# City Plan Commission

July 6, 2021

# “The Preserve at Pippin Orchard”

Master Plan - Major Subdivision

# ELEVATIONS

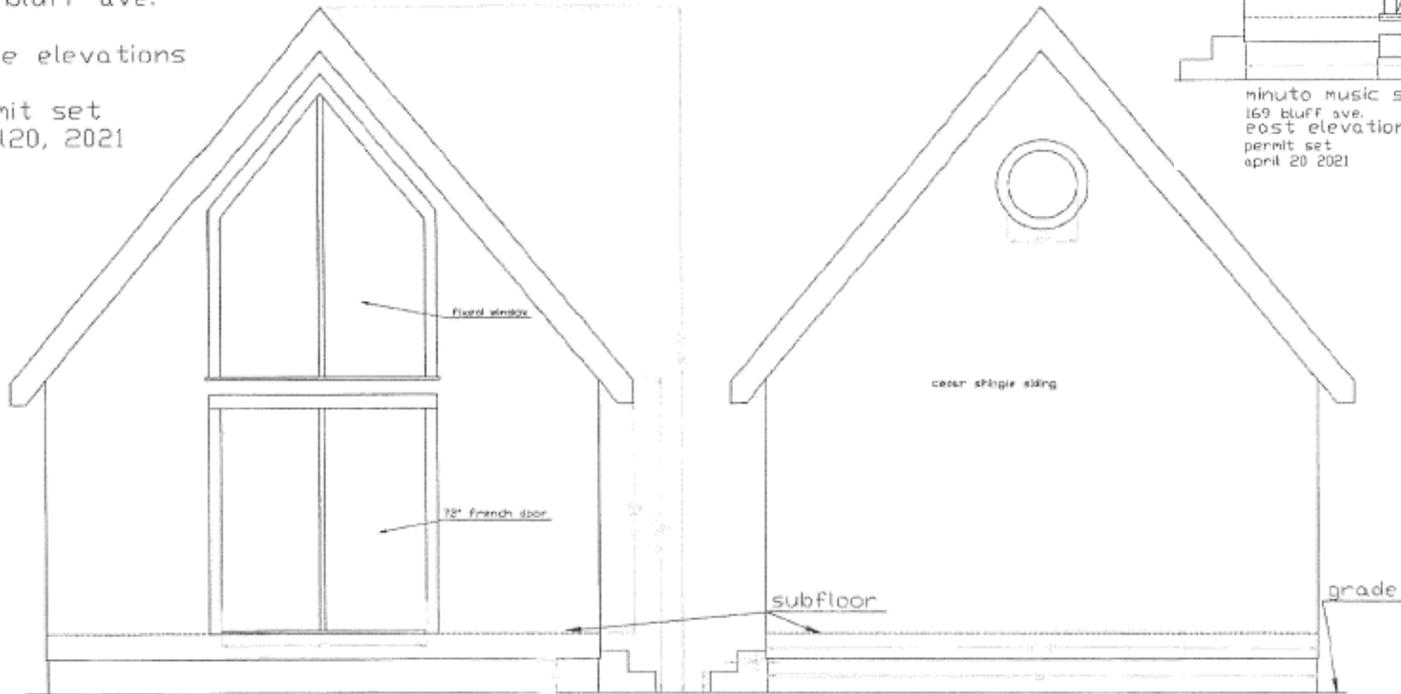
- The proposed structure complies with the accessory structure setbacks;
- The proposed structure will have a bathroom and utilities, but is NOT a dwelling unit;
- There is *NO* proposed commercial/business use of the structure, the proposed use is storage and art/music studio.

- Visual impacts will be mitigated by the existing fence and vegetation (buffers are NOT required)
- Accessory structures are not directly addressed by the Comp Plan;
- Comp Plan LUP-4 reads, “Protect and stabilize existing residential neighborhoods by basing land use decision on neighborhood needs and quality of life. Protect the natural, historic and visual resources that define the neighborhoods” (p. 34).
- Staff finds the request generally consistent with the Comp Plan.

Due to the findings that the application is generally consistent with the Cranston Comprehensive Plan and that no negative impacts are anticipated, staff recommends the Plan Commission forward a *positive recommendation* on the application to the Zoning Board of Review.

# SITE PLAN

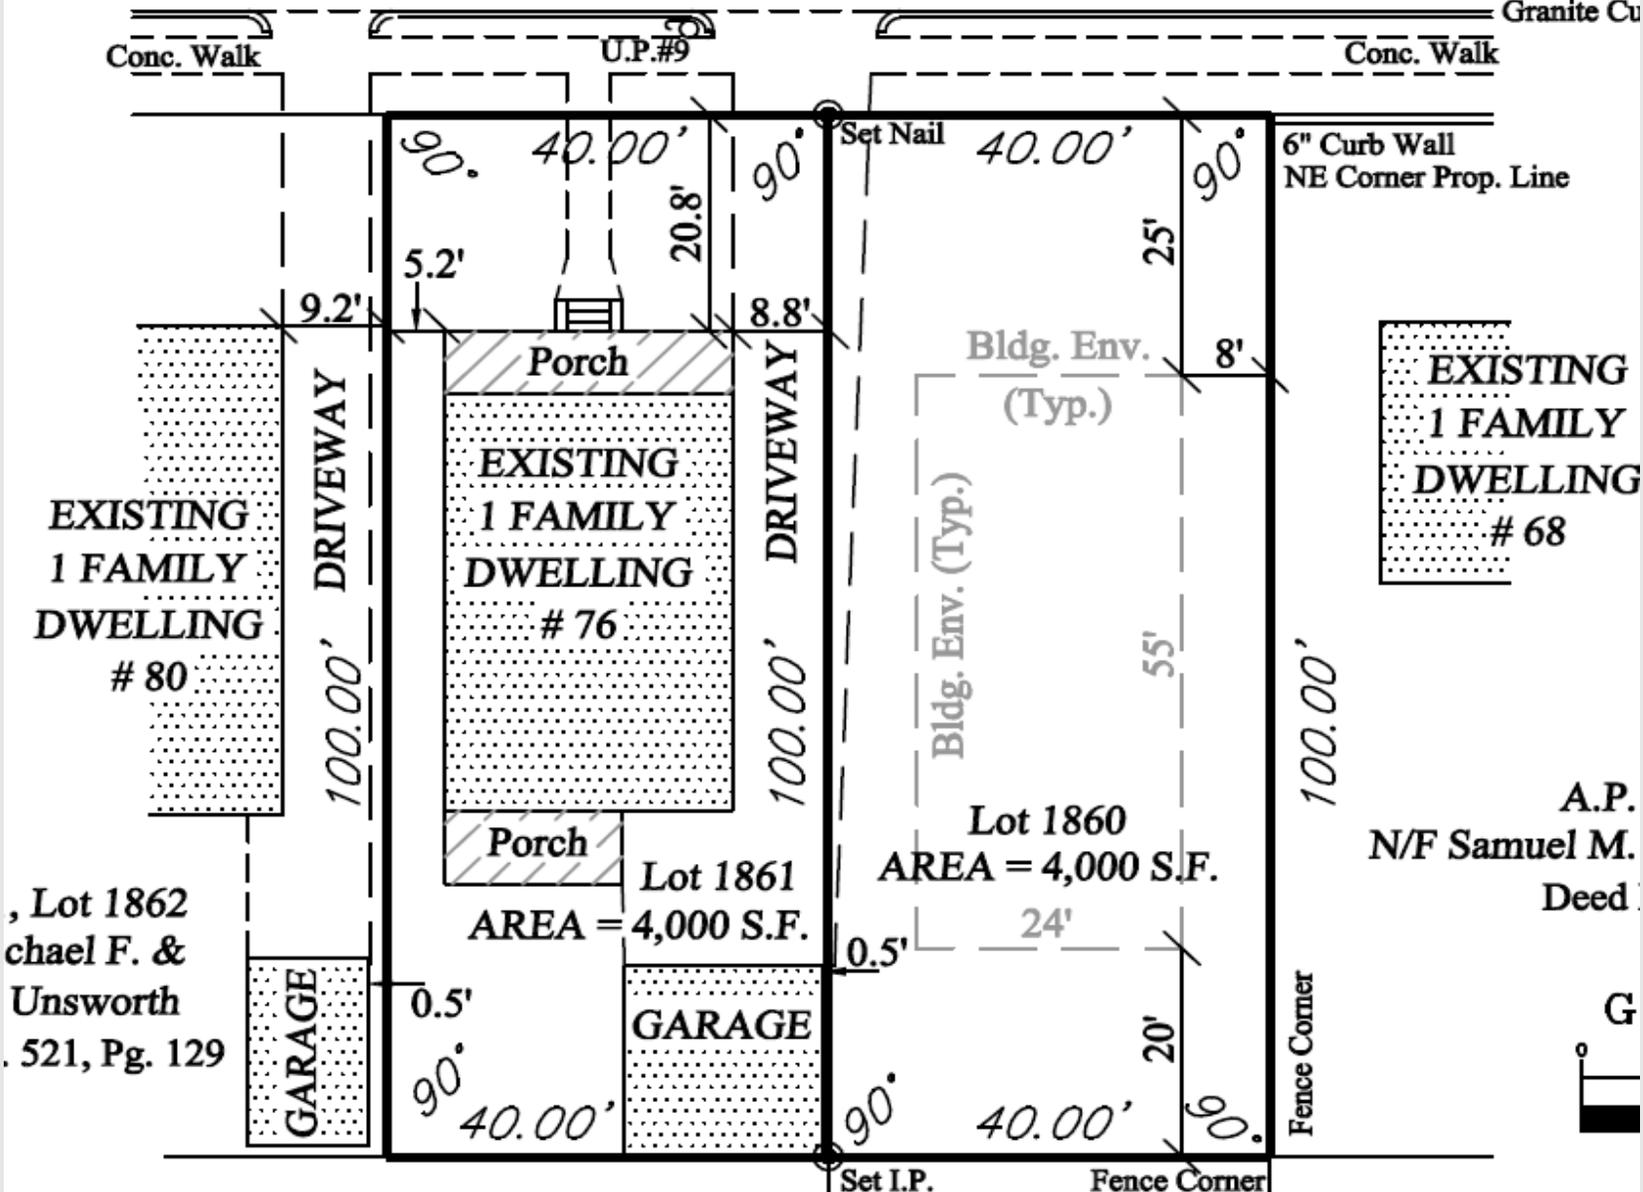
- The proposed 24' x 38' shotgun ranch would comply with zoning setbacks and conforms to the neighborhood;
- 9 of the 12 lots on the same side of the block are 4,000 ft<sup>2</sup> so the lots conform to the neighborhood;
- The proposal is consistent with the proposed uses but inconsistent with the maximum density of the FLUM;
- The Proposal is consistent with several policies in the Comp Plan.

Due to the finding that the application is consistent with the Cranston Comprehensive Plan Housing Element policies, and due to the finding that the proposal generally conforms to the neighborhood, staff recommends the Plan Commission forward a *positive recommendation* on the application to the Zoning Board of Review.
